Application for Fence Exemption – 188 York Mills Road

Date: September 26, 2022

From: Manager Municipal Licensing & Standards, East District

Attachment 3: Photo of patio door providing direct access to pool

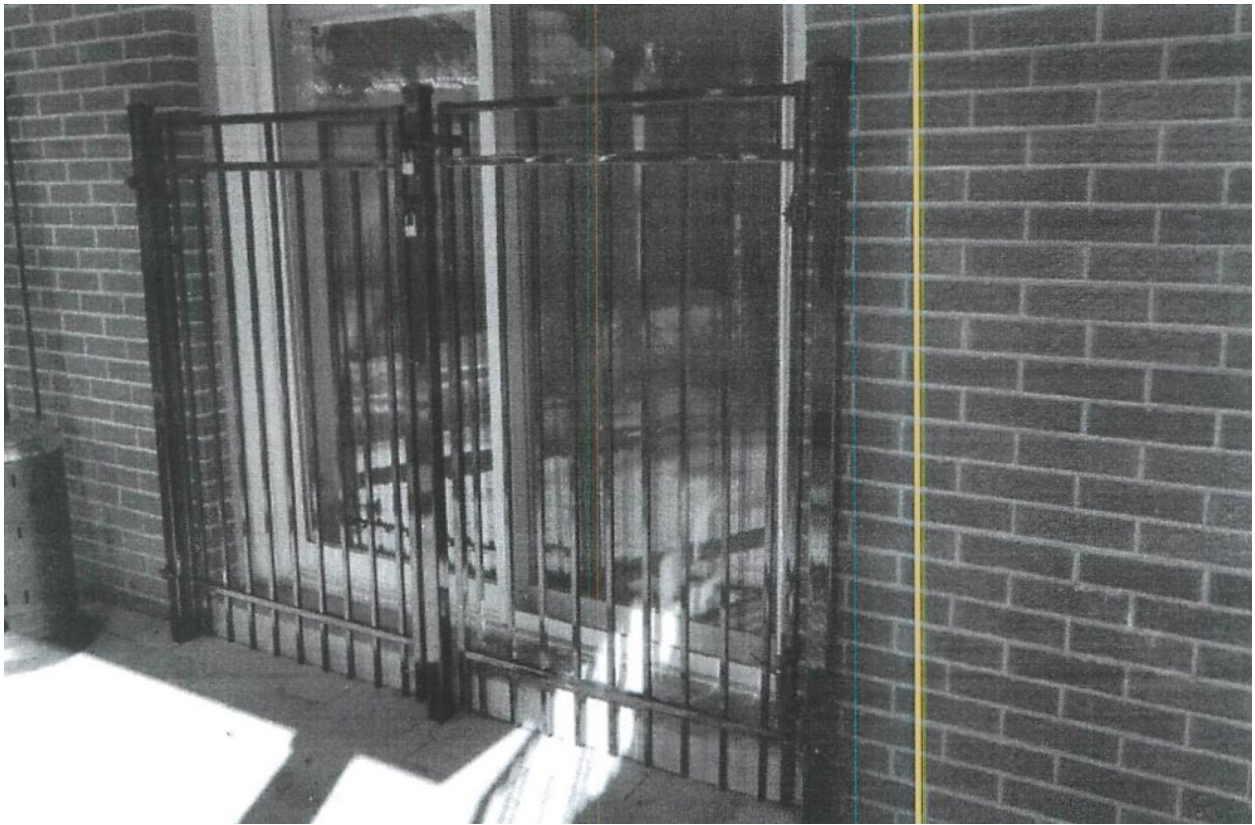
GENERAL LOCATION	SPECIFIC LOCATION	CONSTRUCTION & DEFICIENCY	BY-LAW SECTION & REQUIREMENT*
Rear yard	East and West Patio doors	Current pool enclosure does not include a 4 th fence preventing direct access to pool area.	447-1.3(C)3 Access Protection If the wall of any building, or any portion of it, forms part of the pool enclosure, there shall be no access to the enclosed pool area through the wall.
